**ADMINISTRATIVE AMENDMENT**

FILE # <sup>SI-2020-0103</sup> 3 PROJECT # <sup>PR-2020-00448</sup> 5

Change in use from restaurant to financial center

**CHASE RETAIL BANKING CENTER**  
 EURANK BLVD. NE & CHICO ROAD NE  
 340 EURANK BLVD. NE  
 ALBUQUERQUE, NEW MEXICO 87123

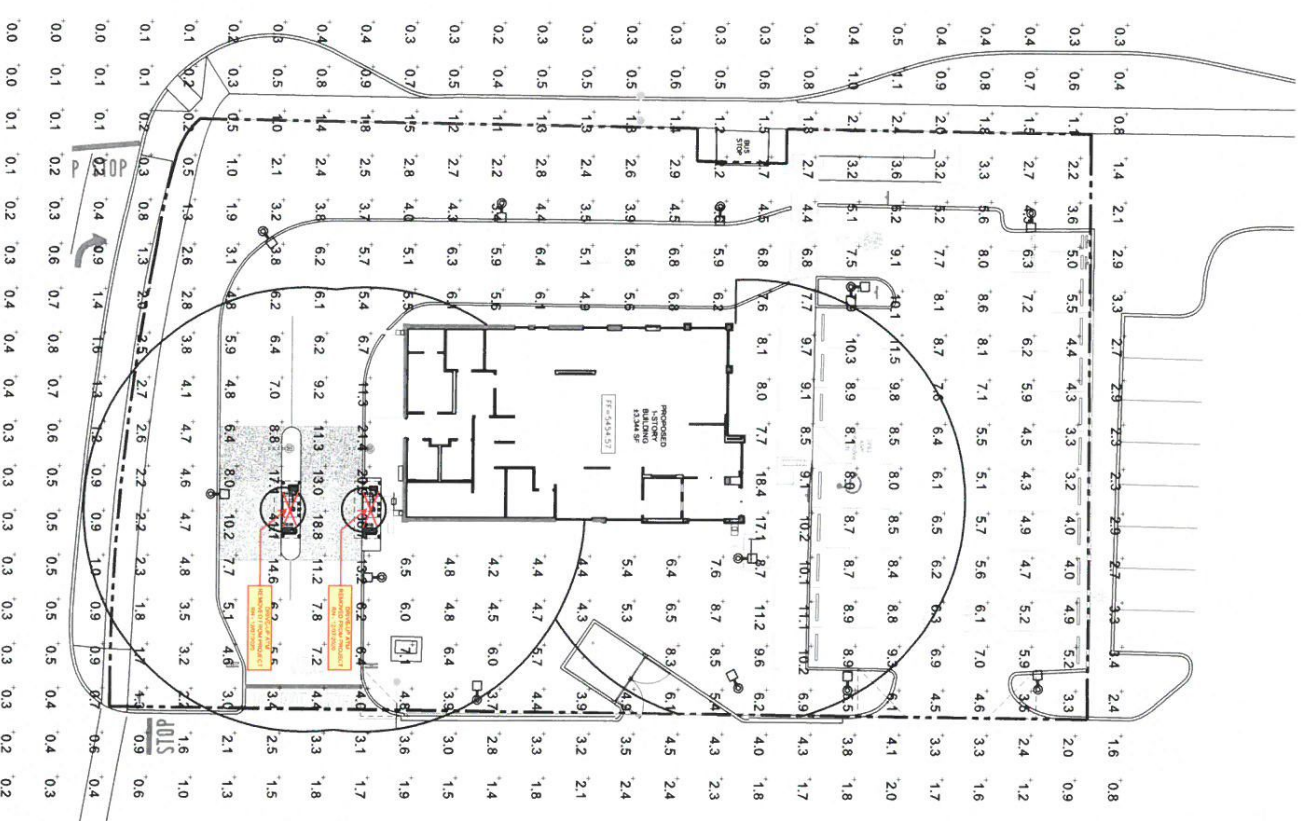
Removal of (2) drive up ATMs
